Access Compliance Report

Public Rights-of-Way

Intersection ID: 45136	Main Street: LITTLE_WHITEOAK_RD	Cross Street: FAWN_CROSSING_CT	Location: W
ADA ID: 849190FA781E	Ramp Type: PerpDiag	Initial Pass/Fail: Fail	Overall Compliance: No
Severity Score: 21.25			
Codes/Mitigation Info/Possible Solution		Field Measurements/Component Compliance

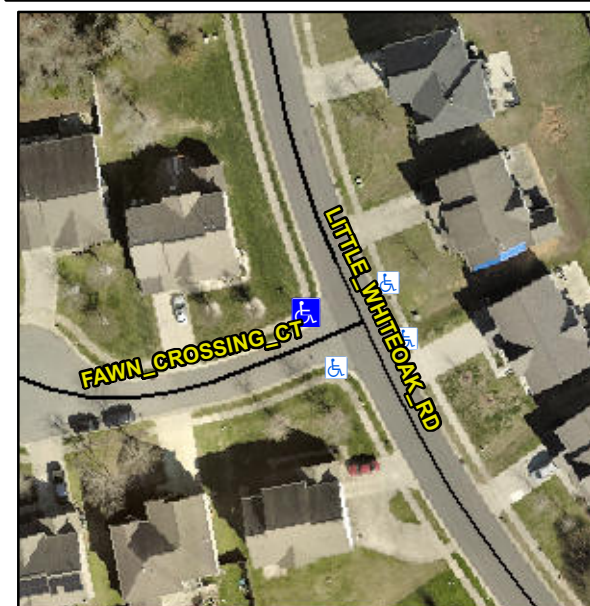
Not Found, R304.5.1, R304.5.3

Compliance	Description	Data	Compliance	Description	Data
N/A	Ramp Length (in)	46.5	Yes	Ramp Slope (%)	6.1
No	Ramp Width (in)	40.0	No	Ramp XSlope (%)	6.8
N/A	Flare Type LT	N/A	N/A	Flare Type RT	N/A
N/A	Flare Slope LT (%)	N/A	N/A	Flare Slope RT (%)	N/A
N/A	Flare Traversable LT?	N/A	N/A	Flare Traversable RT?	N/A
N/A	Landing Length (in)	N/A	N/A	DWS Provided?	N/A
N/A	Landing Width (in)	N/A	N/A	DWS Contrast?	N/A
N/A	Landing Slope (%)	N/A	N/A	DWS Length (in)	N/A
N/A	Landing X Slope (%)	N/A	N/A	DWS Full Width?	N/A
N/A	Landing Curb? (Y/N)	N/A	N/A	DWS Offset (in)	N/A
N/A	Shared Landing?	N/A			
N/A	Gutter Ponding?	N/A	N/A	Gutter Slope (%)	N/A
N/A	Gutter Lip Ht (in)	N/A	N/A	Gutter X Slope (%)	N/A
N/A	Painted X Walk1?	No	N/A	Painted X Walk2?	No
	X Walk 1 Direction	To S		X Walk 2 Direction	To E
N/A	X Walk 1 Width (in)	N/A	N/A	X Walk 2 Width (in)	N/A
	X Walk 1 Slope (%)	1.6		X Walk 2 Slope (%)	3.8
	X Walk 1 X Slope (%)	5.0		X Walk 2 X Slope (%)	4.2

Remove & Replace Curb Ramp With Two New Directional Ramps or Equivalent.
